RENESAS TECHNICAL UPDATE

Product Category	MPU & MCU		Document No.	TN-RX*-A114A/E	Rev.	1.00
Title	Corrections to User's Manual regarding the FASR.EXS bit for the Flash Memory in the RX110 Group		Information Category	Technical Notification		
Applicable Product	RX110 Group	Lot No.	Reference Document	RX110 Group User's Manual: Hardware Rev.1.00 (R01UH0421EJ0100) Specification Changes to the RX110 Group (TN-RX*-A112A/E) Corrections to Descriptions for the Flash Memory in the RX110 Group User's Manual (TN-RX*-A113A/E)		
		All

This document describes corrections to the description for the FASR.EXS bit in section 31. Flash Memory of RX110 Group User's Manual: Hardware Rev.1.00.

Figure 31.10 Procedure to Issue the Start-Up Area Information Program Command/Access Window Information Program Command

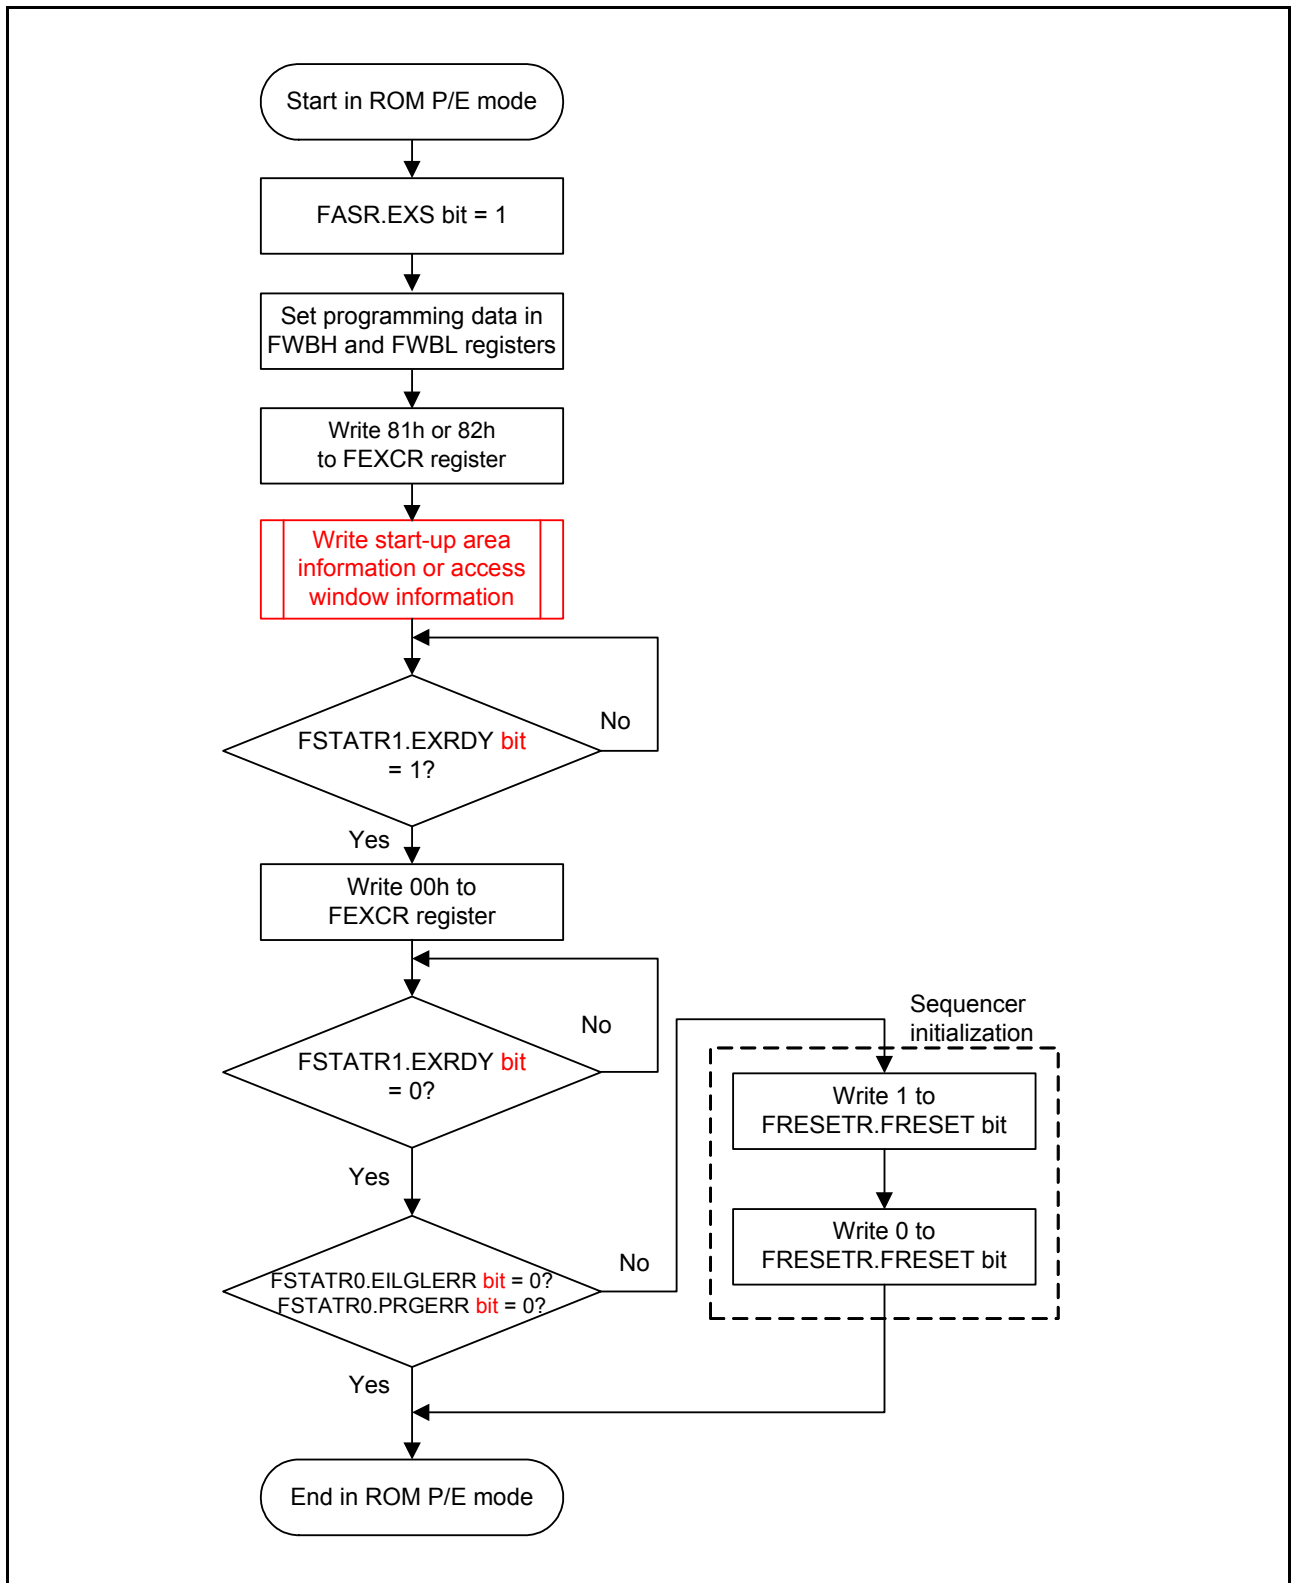
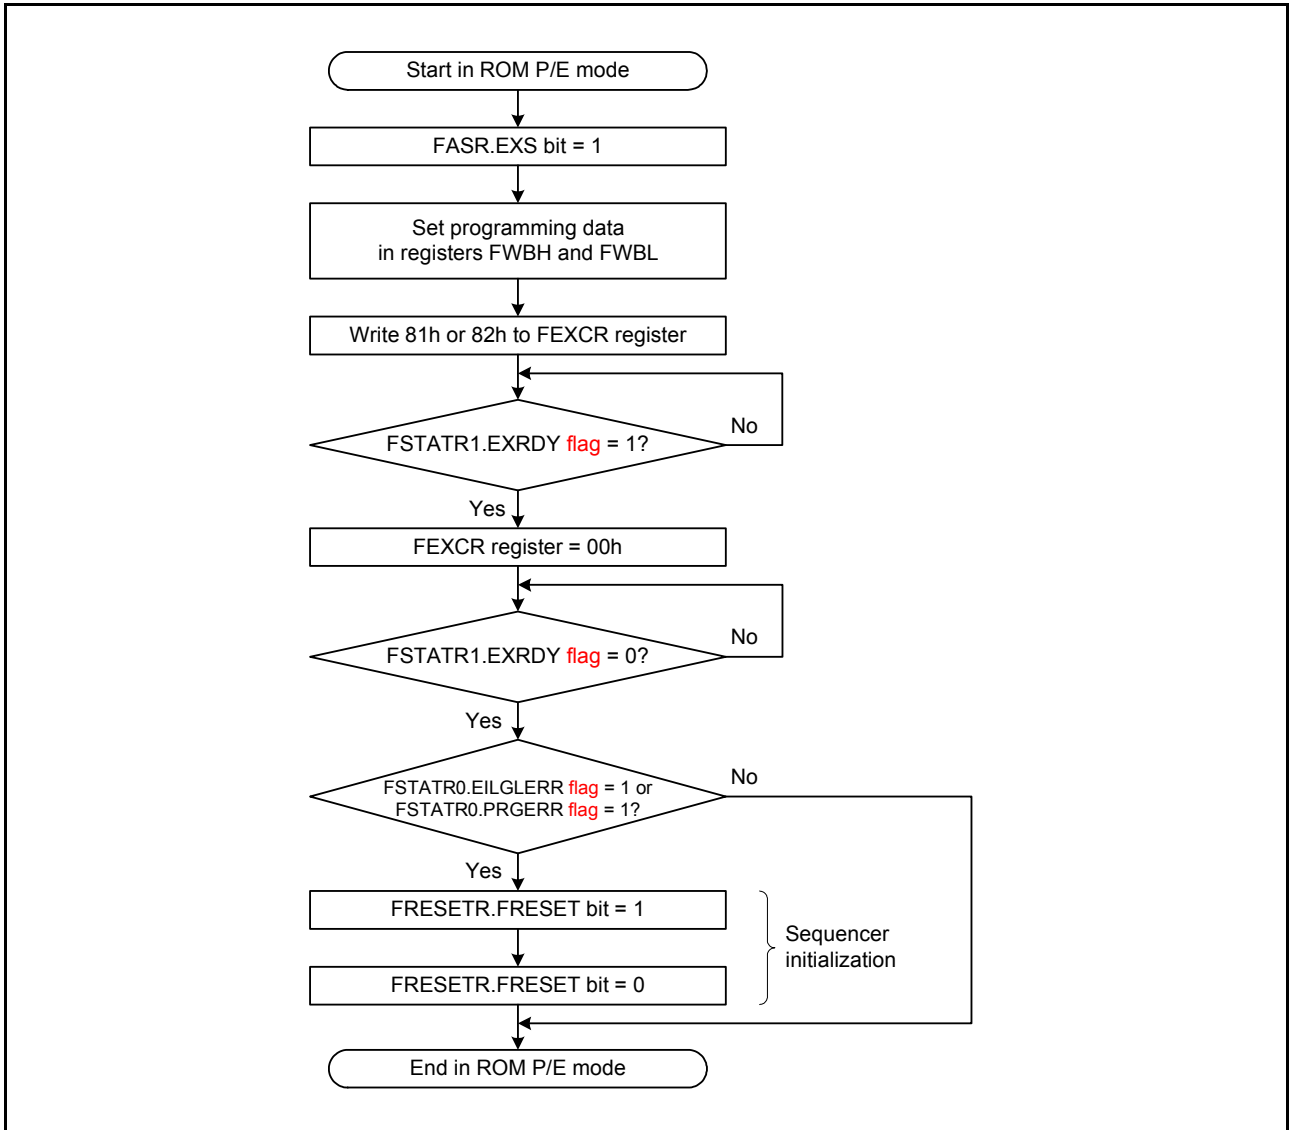
Figure 31.10 in (4) Start-Up Area Information Program/Access Window Information Program of 31.6.3 Software Command Usage is corrected as follows:
